DNAworkshop
DYKE NELSON ARCHITECTURE
235 South 14th Street, Baton Rouge, Louisiana 70802 [225] 224 3363 DNA-Workshop.com

ADDENDUM 4

7/18/2025
Capstone at Covington Place
24-064

The Banyan Foundation

A120

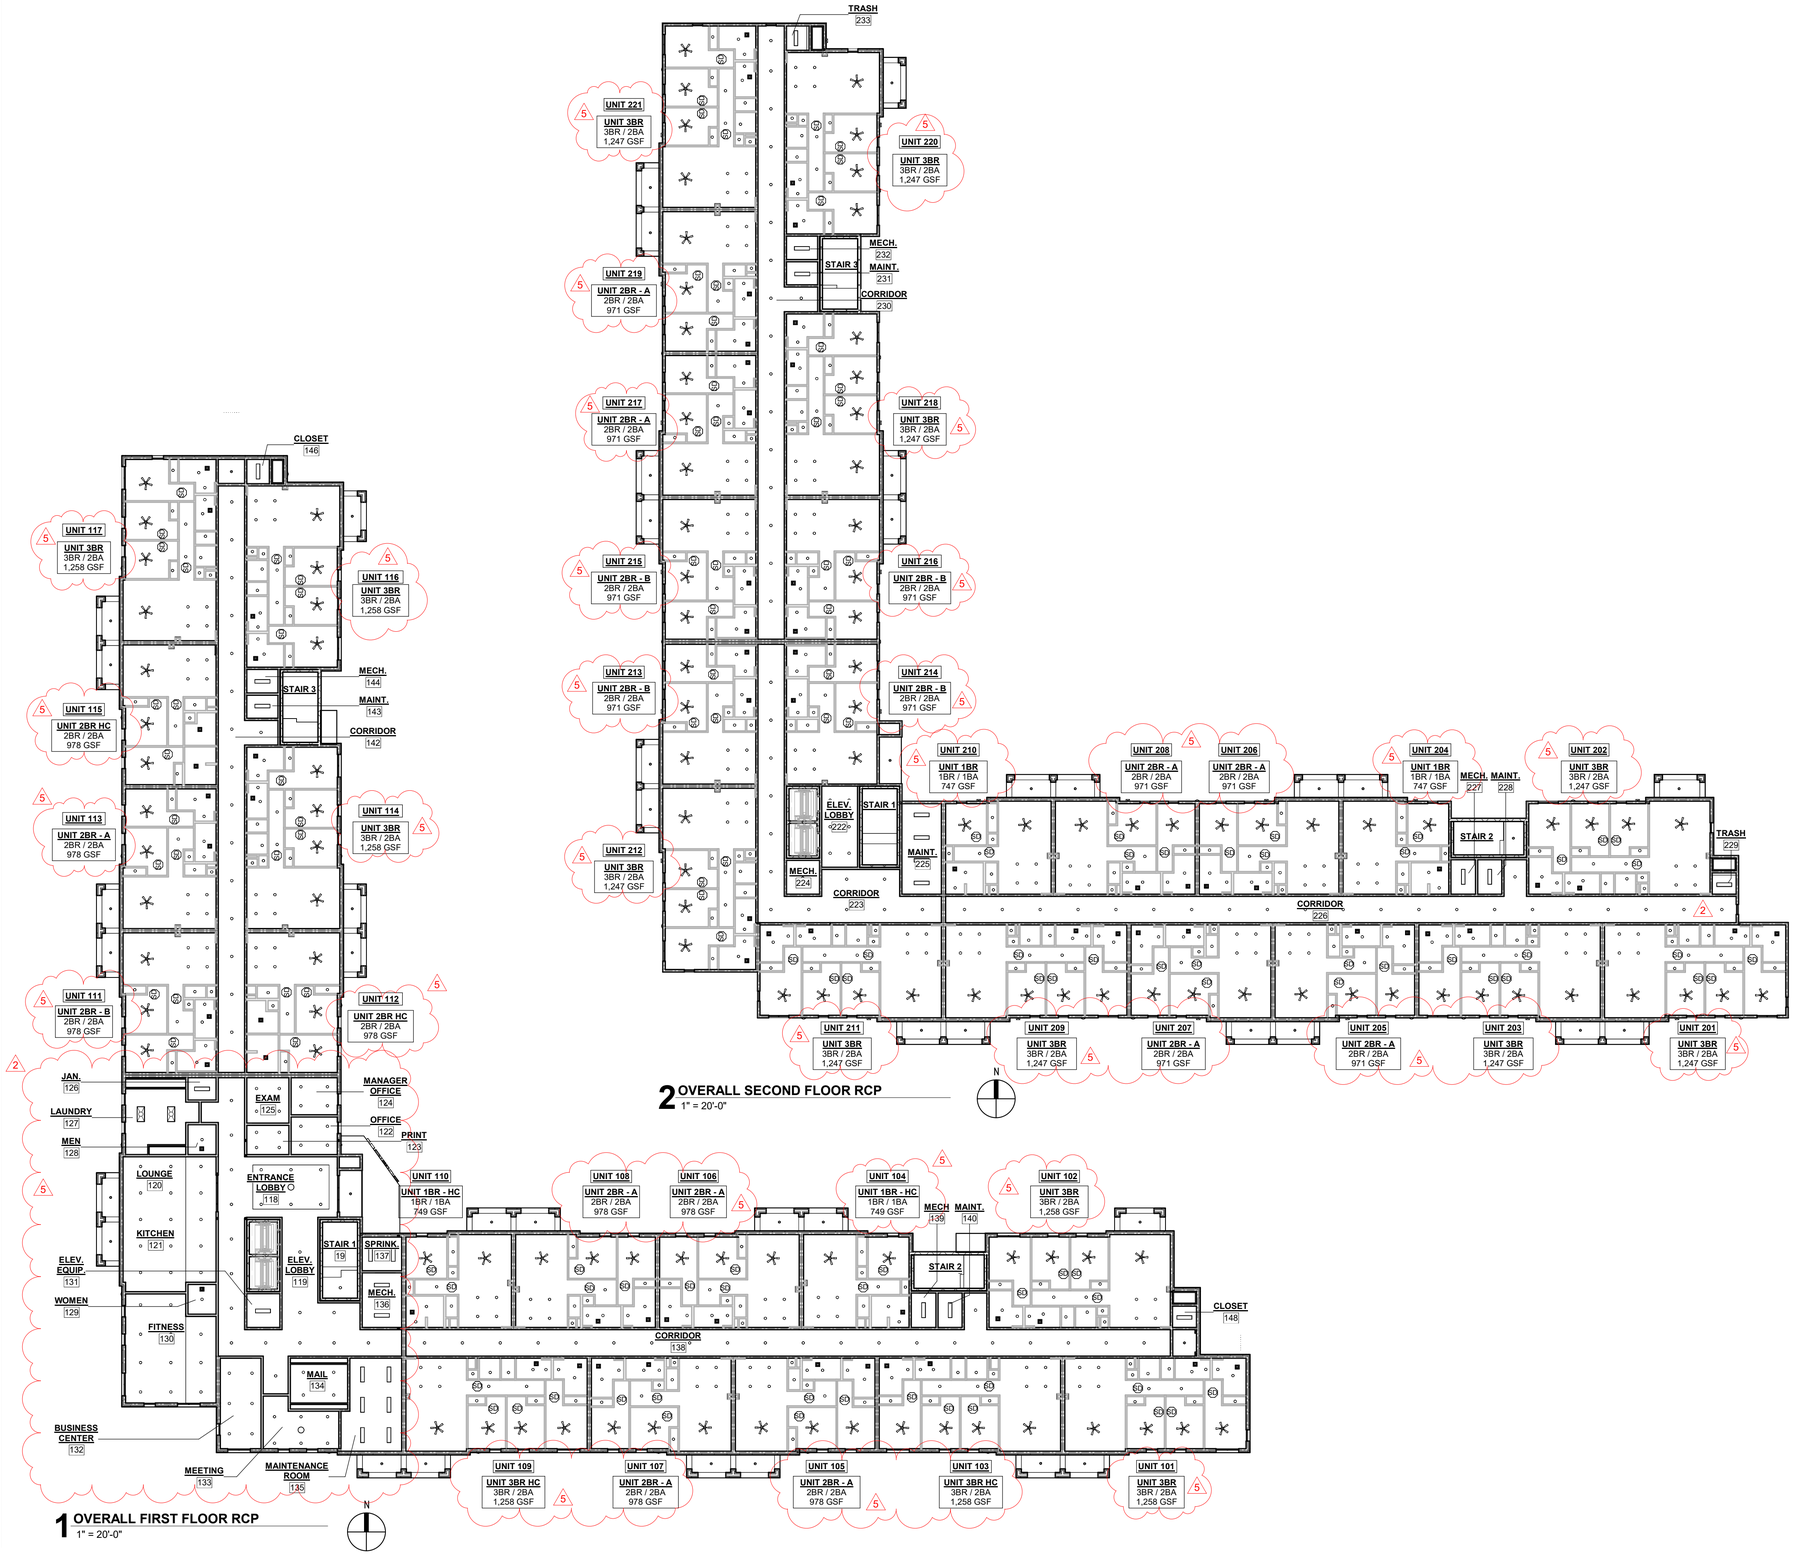
Add 1.7 **A120 – Roof Plan**

- Note the deletion of the wood trellis along with the outdoor seating on the second floor.
- Note the reduction in square footage of the Elevator Loft.
- Note the addition of draft stops to the Roof Plan and Legend.

A501

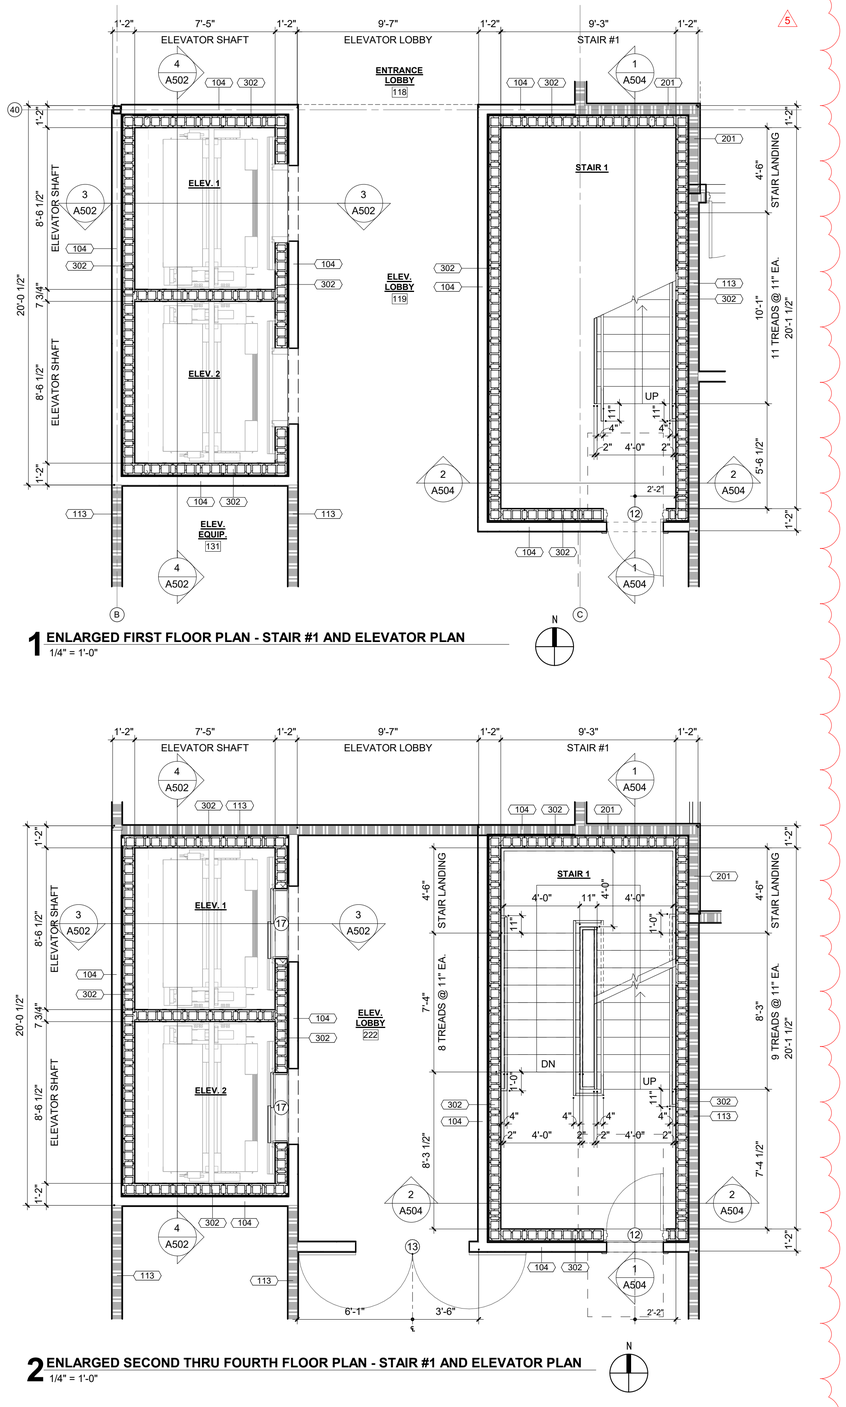
Add 1.15 **A501 – Enlarged Trash Room Plans and Trash Chute Detail**
